A585 Windy Harbour to Skippool Improvement Scheme

8.3 Draft Statement of Common Ground with the Environment Agency

**STATEMENT OF COMMON GROUND WITH THE
ENVIRONMENT AGENCY**

Regulation Number:	Regulation 5(2)(q)
Planning Inspectorate Scheme Reference	TR010035
Application Document Reference	TR010035/APP/8.3
Author:	A585 Windy Harbour to Skippool Improvement Scheme Project Team, Highways England

Figure 2-3: North headwall plan

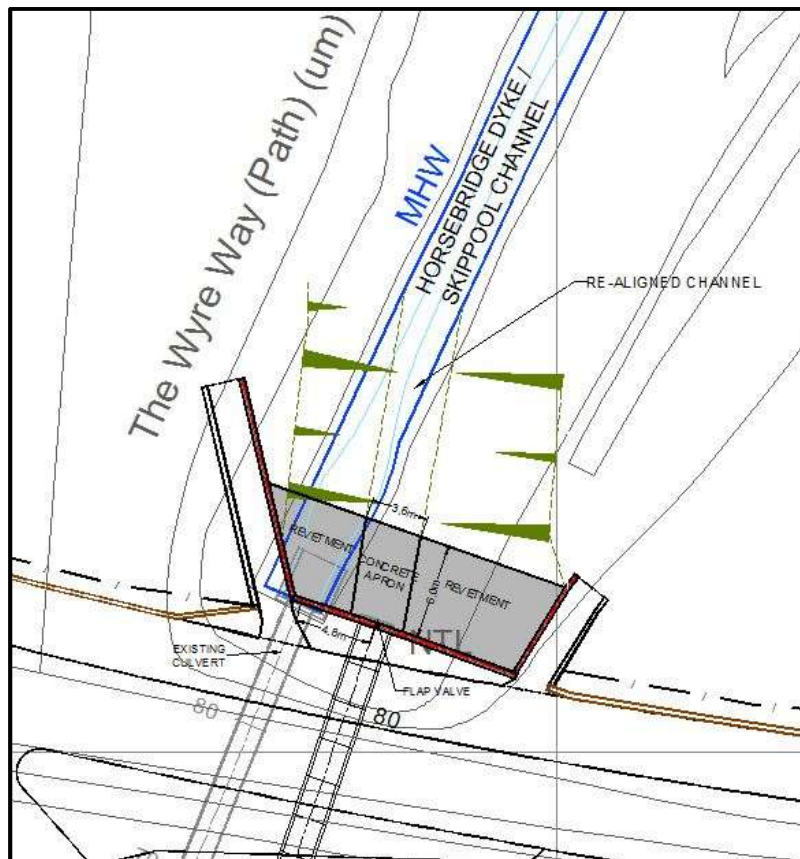
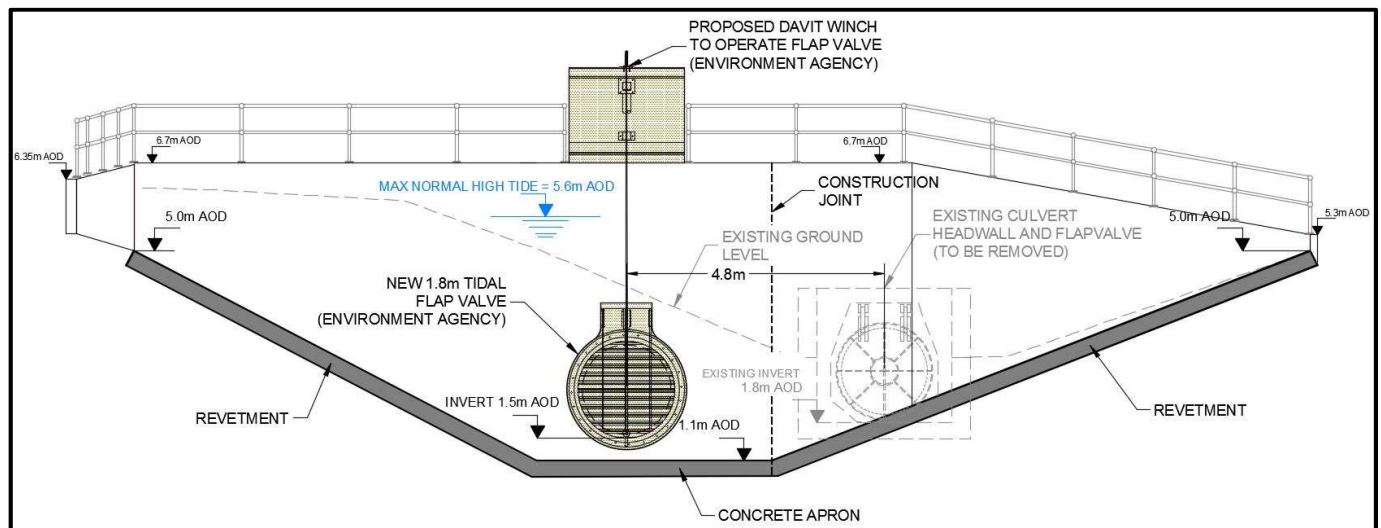
Issue/Topic	EA Comments	Highways England Response / Plan of Action
	<p>structures. The drawings show that the current culvert would be decommissioned, but does not explain what will happen with the inlet and outlet.</p> <p>The drawing shows that the proposed new inlet and outlet are not in line with the existing watercourse channel and therefore have the potential to cause erosion and scour to the existing channel. This does not appear to have been accounted for.</p>	<p>Technical Note providing the EA information on:</p> <ul style="list-style-type: none"> • Why the culvert has to be replaced offline • Why an online replacement simply cannot be accommodated • The impact of the realigned culvert on scour / erosion • Management of scour and erosion • Management of blockage risks <p>Technical Note to be submitted to the EA 12/4/19.</p>
Horsebridge Dyke culvert	We would also want to see the new culvert modelled to provide evidence it does not increase the flood risk in the area	<p>The new culvert dimensions have been included in the fluvial model (Option runs) to assess its effects on baseline flood risk.</p> <p>The enhanced tidal model simulates a scenario whereby the tidal flap on the outfall of this structure is closed (as would be expected during an extreme tidal flood event).</p>

Issue/Topic	EA Comments	Highways England Response / Plan of Action
	<p>We consider that the drawing is not required as part of the DCO application, but it could be more helpful if the following observations were addressed:</p> <ul style="list-style-type: none"> • Due to the scale of the drawing, it is not possible to ascertain whether or not the 8m and 16m 'buffer zones' are correct, and also whether or not they are measured from the top of the bank of the main river. • The drawing does not actually show where you consider flood risk activities to be taking place, other than the approximate location of three highway drainage outfalls. <p>We suggest that a better approach would be to break the overall scheme up into separate sections with the known and possible flood risk activities annotated.</p> <p>We would also recommend annotating that any construction compounds next to any main rivers should be more than 8m from the top of the bank of the main river so our access to the watercourse can be retained.</p>	<p>EA 1 April 2019. Agreed action for Highways England to provide the EA with a package of GIS drawing files to include:</p> <ul style="list-style-type: none"> • Scheme red line boundary • 8m and 16m buffer zones (measured from the top of bank of the Main Dyke and Horsebridge Dyke and Wyre) • Drainage outfall/headwall locations • Drainage ponds • Temporary floodplain storage areas • Main dyke crossing • Horsebridge Dyke replacement culvert alignment, plus inlet/outlet structures • Dwarf walls <p>File issue to the EA by 12/4/19.</p>

Horsebridge Dyke culvert	We currently maintain the tidal outfall and the future maintenance of the new proposed structures would need to be agreed.	Details of future maintenance responsibilities to be included in the updated FRA report and also covered in the Technical Note referenced above.
Potential Flood Risk Activities	Ref drawing HE54864-ARC-EWE-SZ-ZZ-0-DR-LE-4031	Works constituting potential flood risk activities were discussed at a meeting with the
